RAINES ADDITION TO WILDWOOD **SUBDIVISION**

APPLICATION NUMBER Holdover DATE March 20, 2003

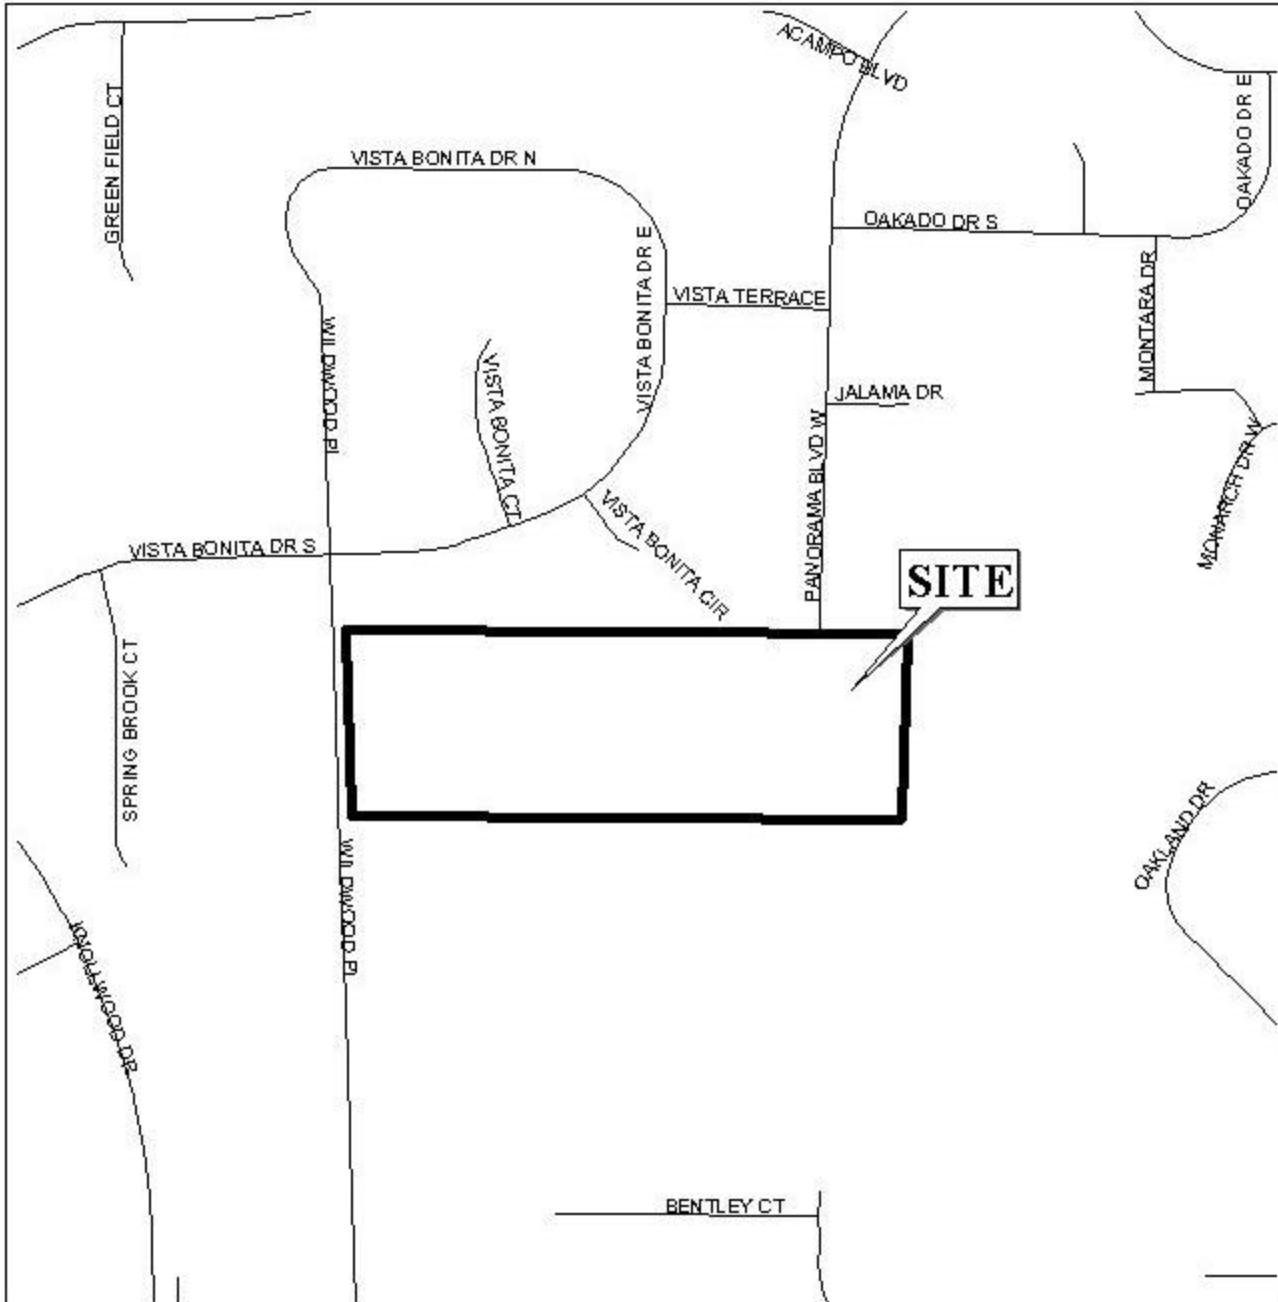
The application was heldover by the Commission at their February 6th meeting. As illustrated on the Vicinity Map, there is an existing drainage easement in the southeast portion of the property that would make continuation of Panorama, from the North property line to South property line, difficult. However, the Subdivision Regulations call for the continuation of existing street stubs (Section V.B.1.), thus the existing street stub

for Panorama Boulevard should connect with the proposed street. The continuation of Panorama Boulevard, to the South property line is no longer recommended.

The applicant requested a holdover at the Commission's February 20th meeting, and although a revised plat was submitted, it appeared the only modification was to illustrate the existing drainage easement at the Southwest corner as 40-feet in width, rather than 30-feet.

With modifications, the plat will meet the minimum requirements of the Subdivision Regulations and is recommended for Tentative Approval subject to the following conditions: 1) that the street stub with Panorama Drive West be continued from the North property line and connect with the new street; 2) full compliance with the City Engineering comments; and 3) that the detention area be labeled as such on the final plat, with a note stating that the maintenance thereof shall be the responsibility of the property owners.
